## Errata: CDB42438 Rev. B2

Reference CDB42438 Data Sheet

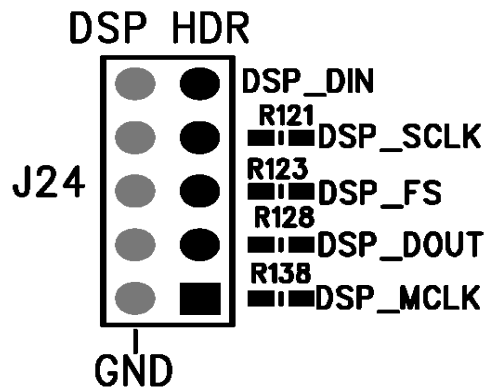
- Stake header J24 is labeled incorrectly. The correct label is shown below:
